RE: Agreement No. 1946F  
Traffic Impact Study Services  
**Task No. 4A Subtask 05 – Addendum #2 to First State Crossing TIS**

McCormick Taylor has completed its review of Addendum #2 of the Traffic Impact Study (TIS) for the First State Crossing mixed-use development, prepared by Traffic Planning & Design, Inc. (TPD). The original TIS was dated June 2019 and was updated in August 2019, Addendum #1 was submitted in February 2020, and Addendum #2 is dated September 2022. TPD prepared the Addendum #2 report in a manner generally consistent with DelDOT's Development Coordination Manual.

FIGURE 2

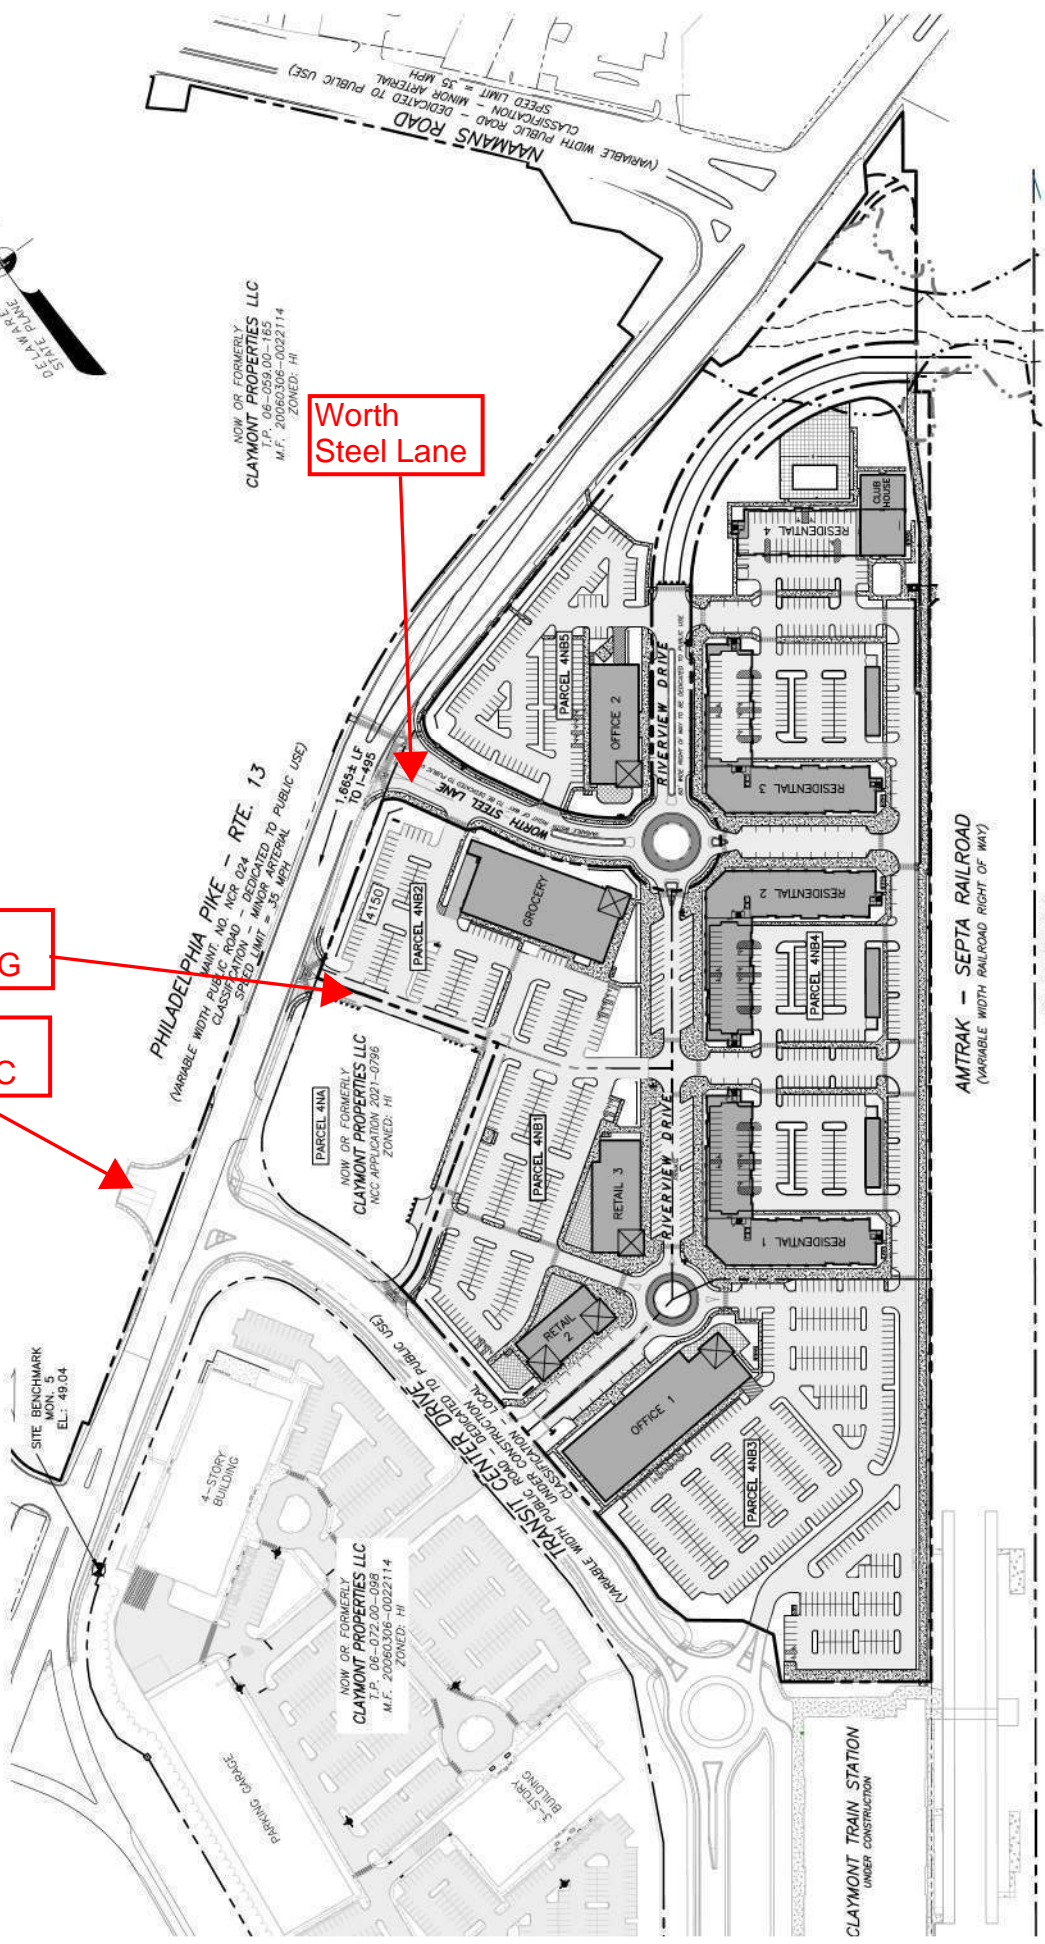
An updated site plan for Site Parcel 4 (Phase 1) was provided in Addendum #2 and is included on page 3 of this review letter. Site Parcel 4 lies east of Philadelphia Pike but west of the AMTRAK/SEPTA rail lines. Based on plans in the original TIS, Site Parcels 1 and 3 (not shown on the updated Addendum #2 site plan) are located west of Philadelphia Pike and south of Naamans Road, while Site Parcel 6 (also not shown on the updated site plan) is located east of the AMTRAK/SEPTA rail lines with a roadway connection through Site Parcel 4 to access Philadelphia Pike. The site plan from Addendum #1, which showed all the site parcels, is provided on page 16 of this Addendum #2 letter for reference to the locations of all site parcels. It is important to note the Addendum #1 site plan shows the possibility of a Spine Road across Naamans Creek (connecting Site Parcels 1 and 3) but that is no longer being considered.
